Technical Service Bulletin

**Solitude 360RL Slide Room Flex-Guard Strap -
DS Dinette Slide**

16-005

Solitude 360RL

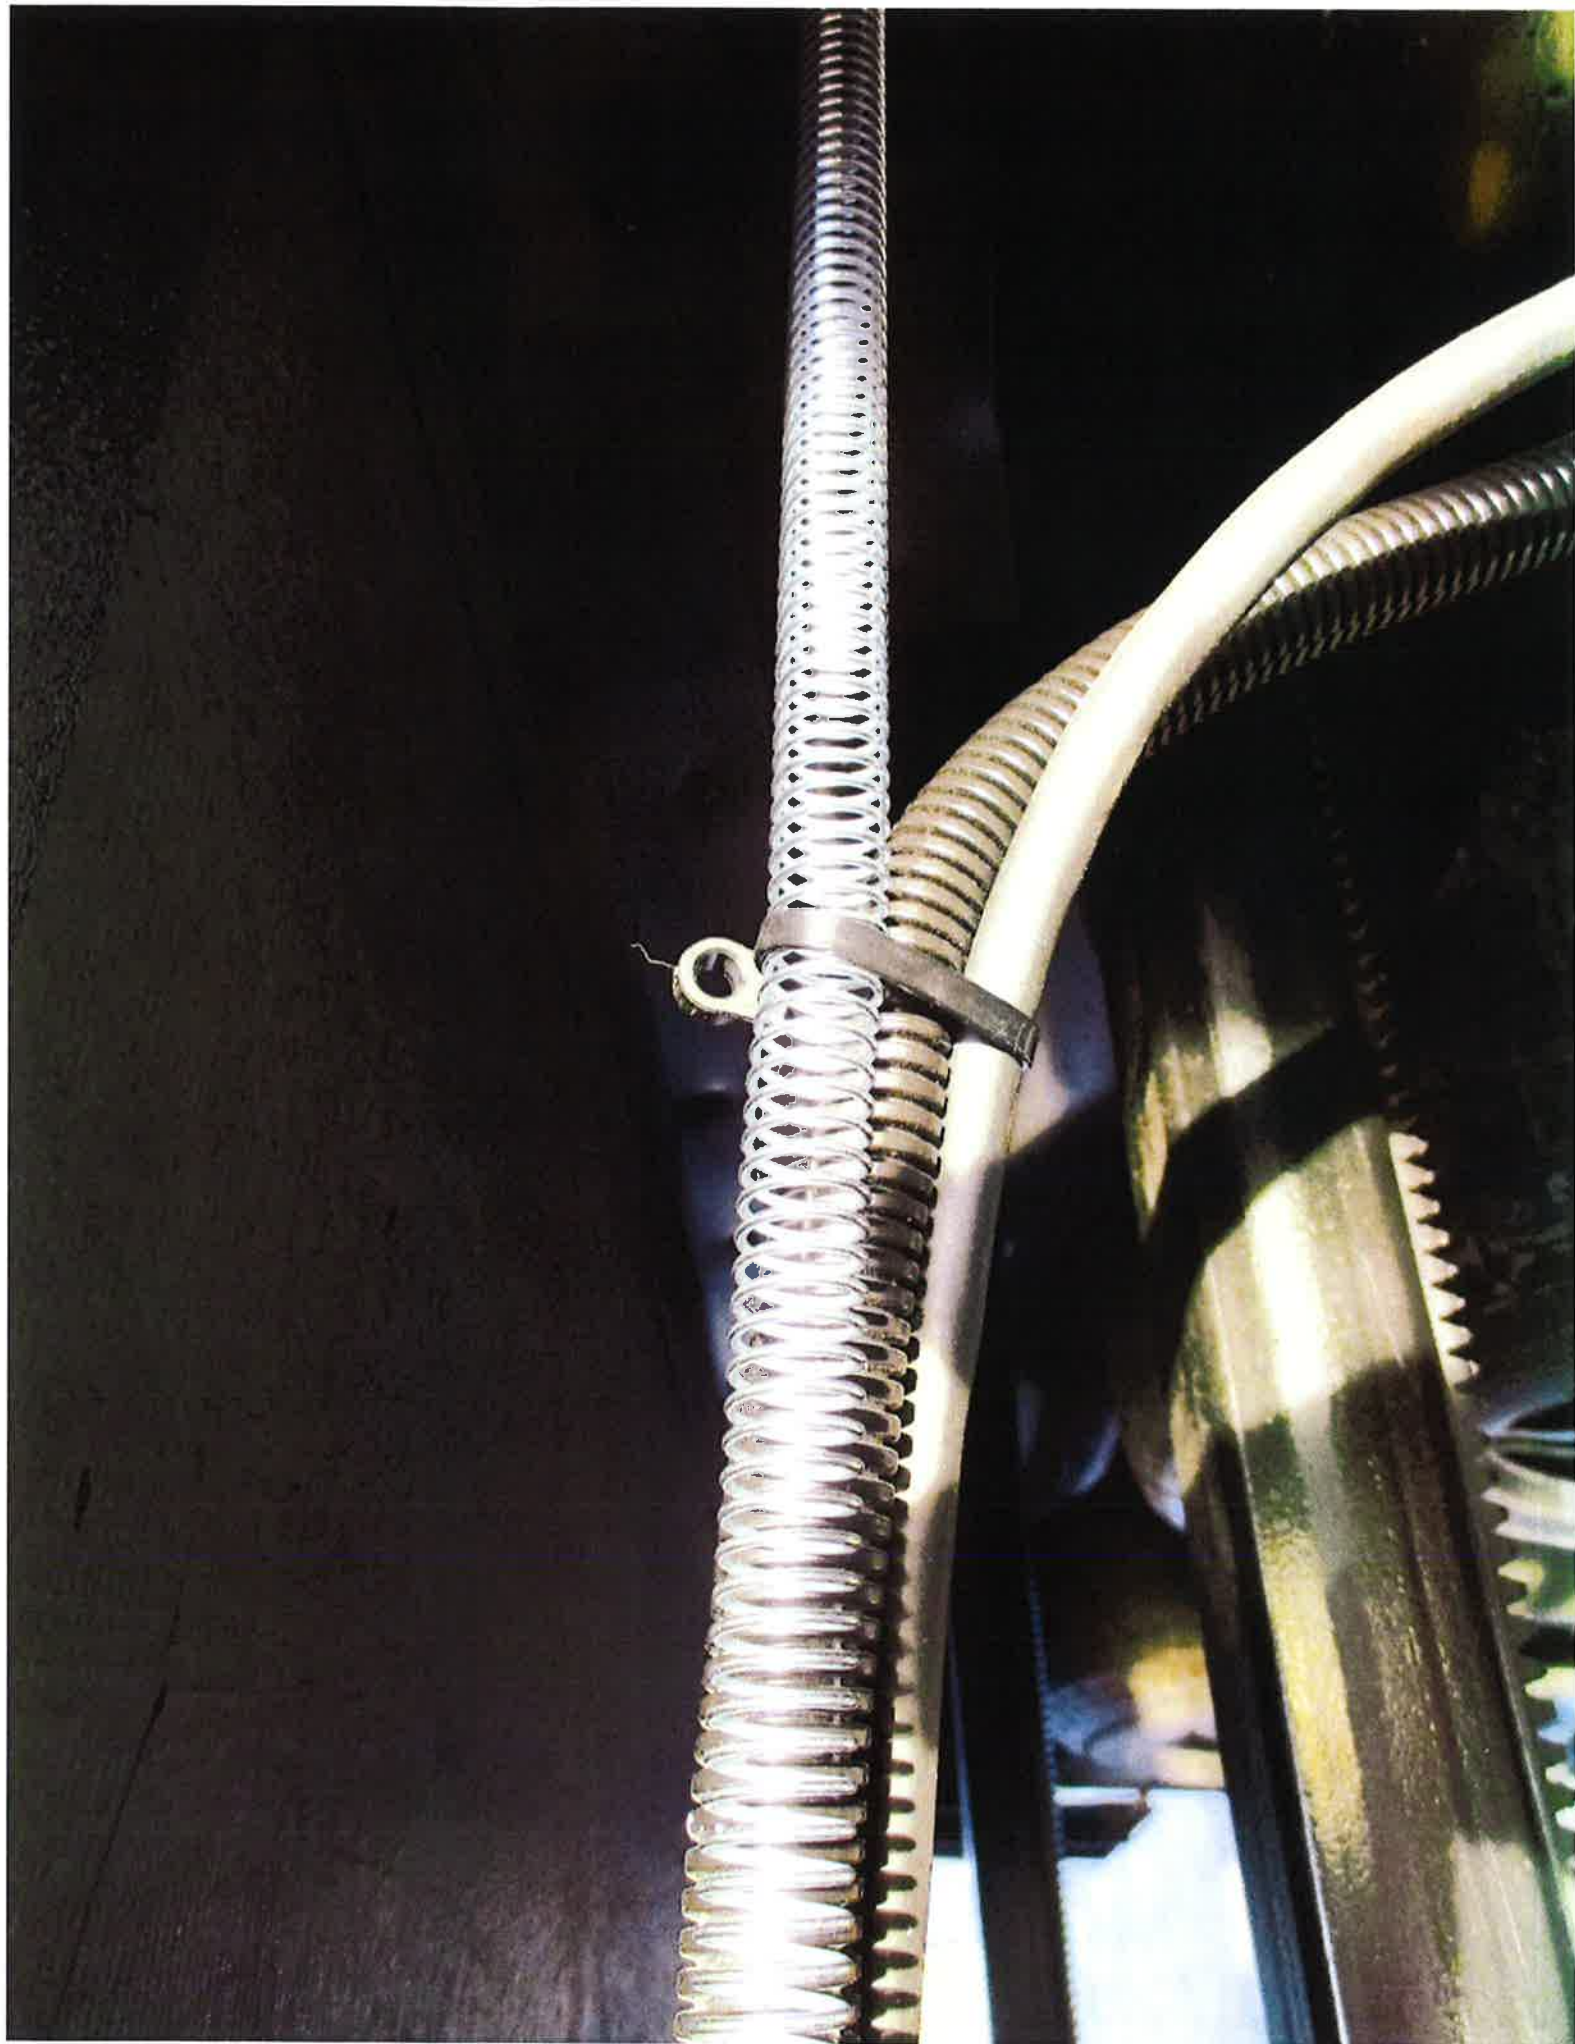
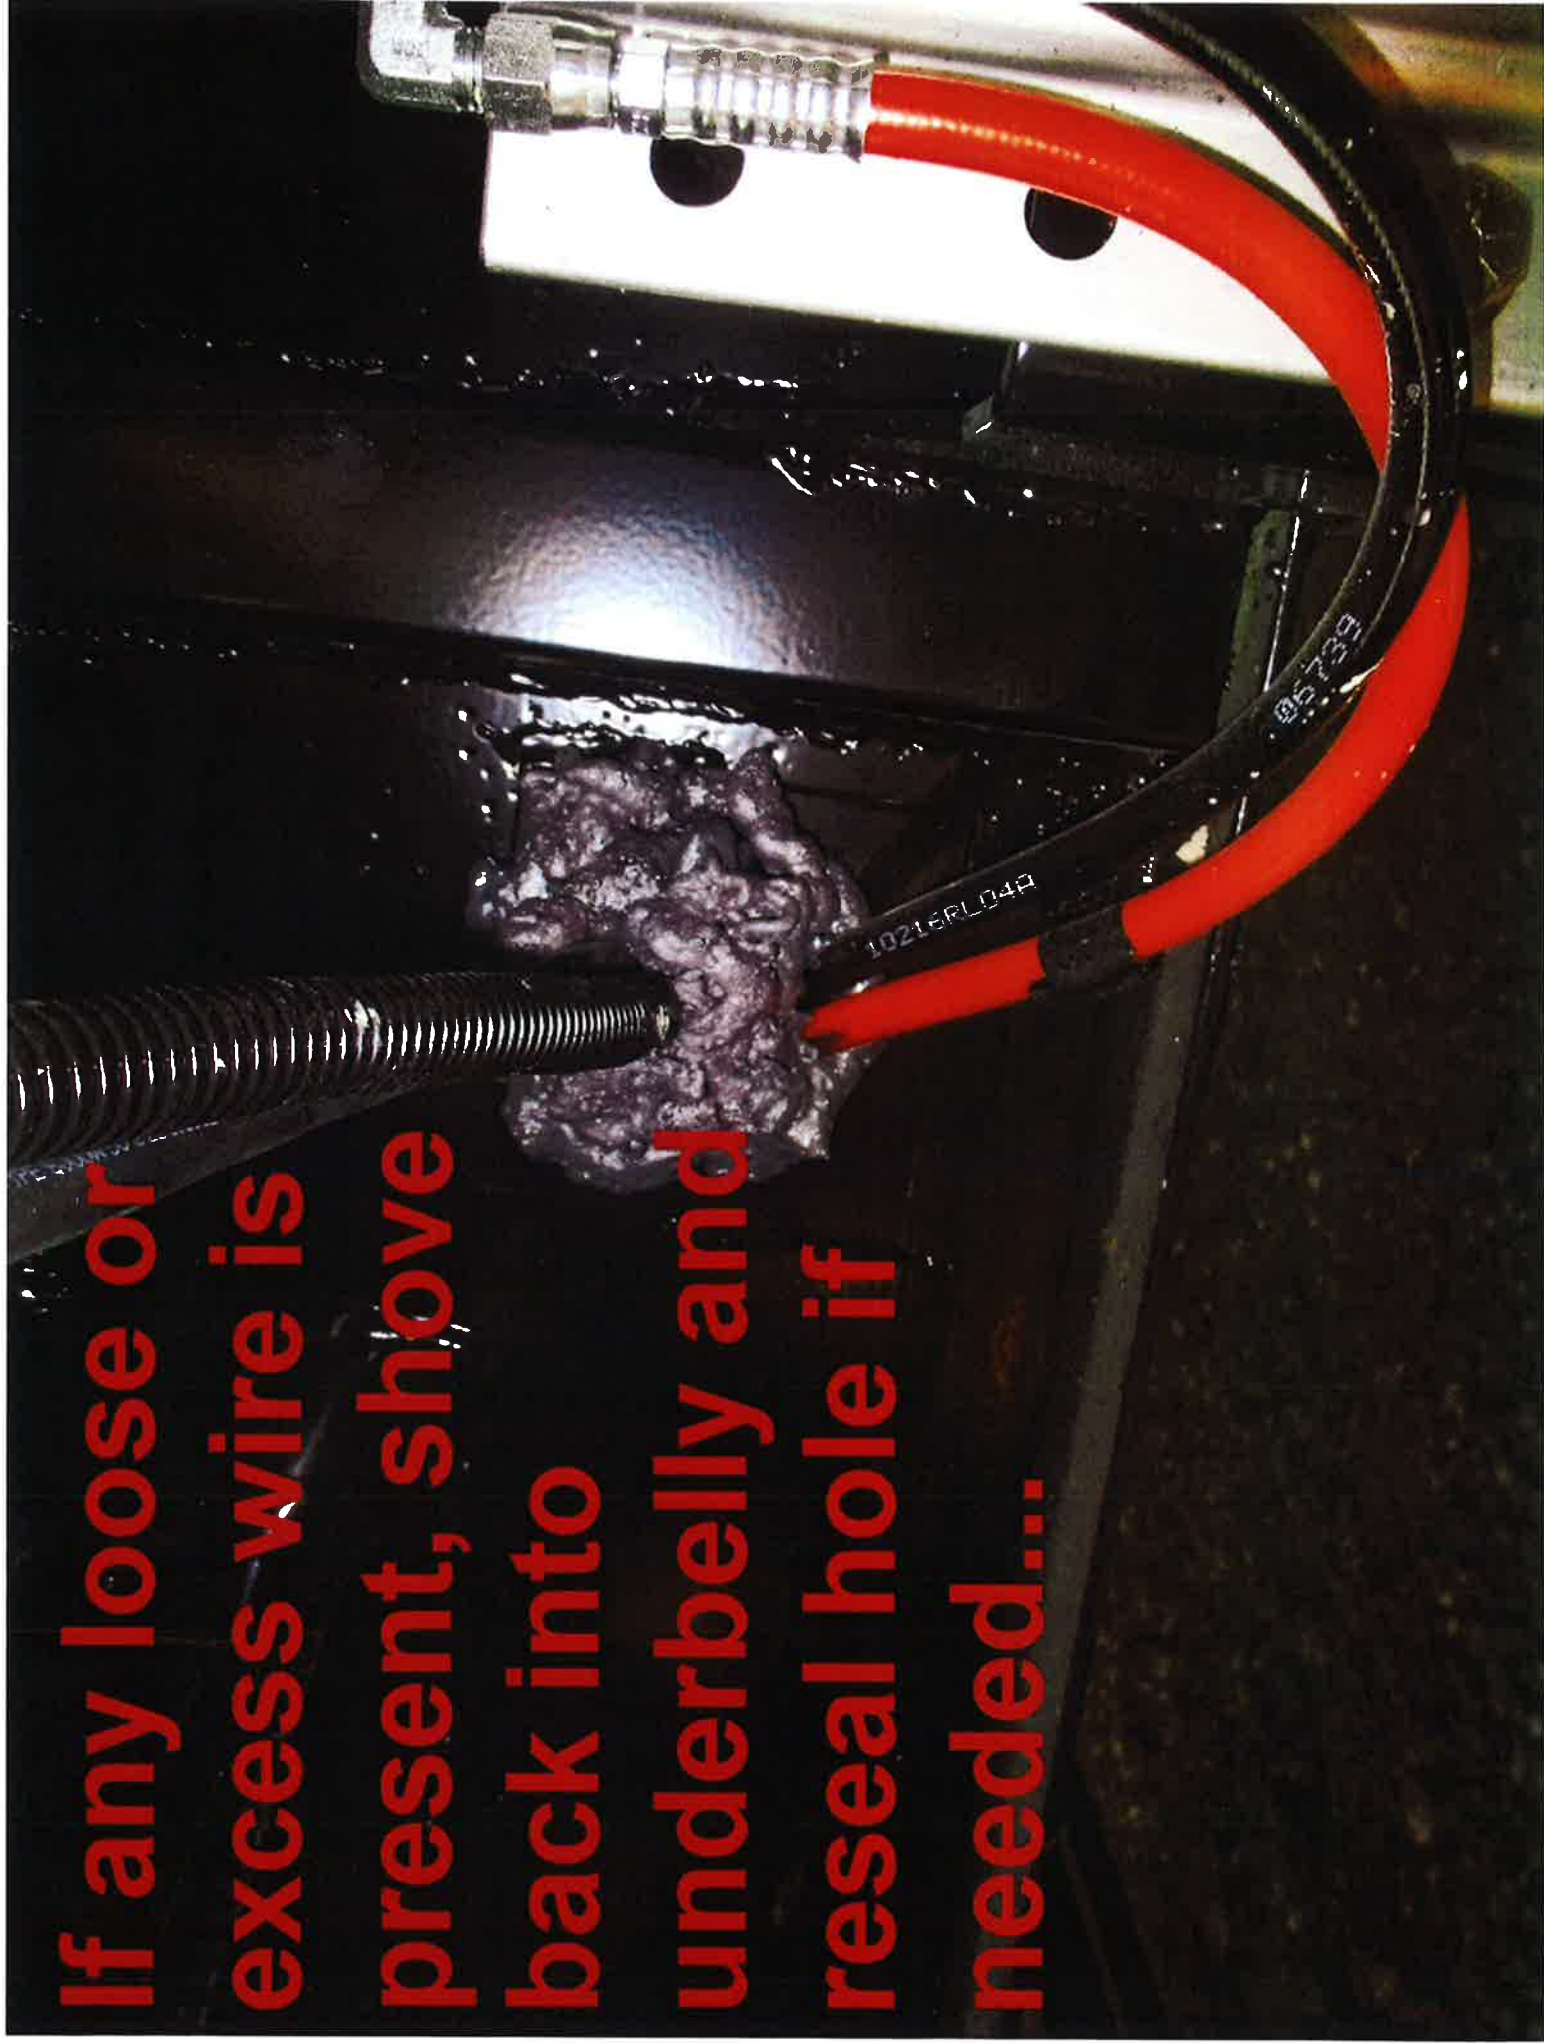
**If any loose or
excess wire is
present, shove
back into
underbelly and
reseal hole if
needed...**

**Completed repair will keep
wires and spring from
possibly rubbing tire...**
